# Access Compliance Report

## Public Rights-of-Way

### (Curb Ramps)

Intersection ID: 7186	Main Street: BEATTIES_FORD_RD	Cross Street: FAIRDALE_DR	Location: SW
ADA ID: 25D8F2A857F2	Ramp Type: PerpDiag	Initial Pass/Fail: Fail	Overall Compliance: No
Severity Score: 33.75			
Codes/Mitigation Info/Possible Solution		Field Measurements/Component Compliance

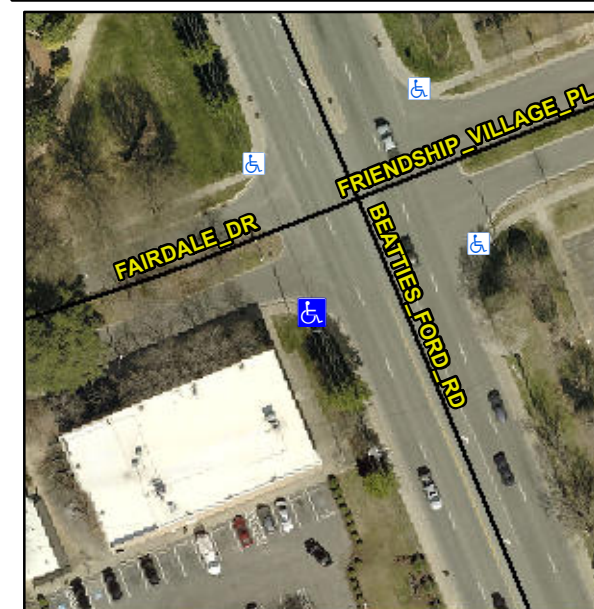
**Not Found, R304.5.1, R304.2.2**

Compliance	Description	Data	Compliance	Description	Data
N/A	Ramp Length (in)	59.5	No	Ramp Slope (%)	12.5
No	Ramp Width (in)	46.0	Yes	Ramp XSlope (%)	0.4
N/A	Flare Type LT	N/A	N/A	Flare Type RT	N/A
N/A	Flare Slope LT (%)	N/A	N/A	Flare Slope RT (%)	N/A
N/A	Flare Traversable LT?	N/A	N/A	Flare Traversable RT?	N/A
N/A	Landing Length (in)	N/A	N/A	DWS Provided?	N/A
N/A	Landing Width (in)	N/A	N/A	DWS Contrast?	N/A
N/A	Landing Slope (%)	N/A	N/A	DWS Length (in)	N/A
N/A	Landing X Slope (%)	N/A	N/A	DWS Full Width?	N/A
N/A	Landing Curb? (Y/N)	N/A	N/A	DWS Offset (in)	N/A
N/A	Shared Landing?	N/A			
N/A	Gutter Ponding?	N/A	N/A	Gutter Slope (%)	N/A
N/A	Gutter Lip Ht (in)	N/A	N/A	Gutter X Slope (%)	N/A
N/A	Painted X Walk1?	No	N/A	Painted X Walk2?	No
	X Walk 1 Direction	To NE		X Walk 2 Direction	To NW
N/A	X Walk 1 Width (in)	N/A	N/A	X Walk 2 Width (in)	N/A
	X Walk 1 Slope (%)	1.2		X Walk 2 Slope (%)	0.4
	X Walk 1 X Slope (%)	0.3		X Walk 2 X Slope (%)	0.2

**Remove & Replace Curb Ramp With Two New Directional Ramps or Equivalent.**
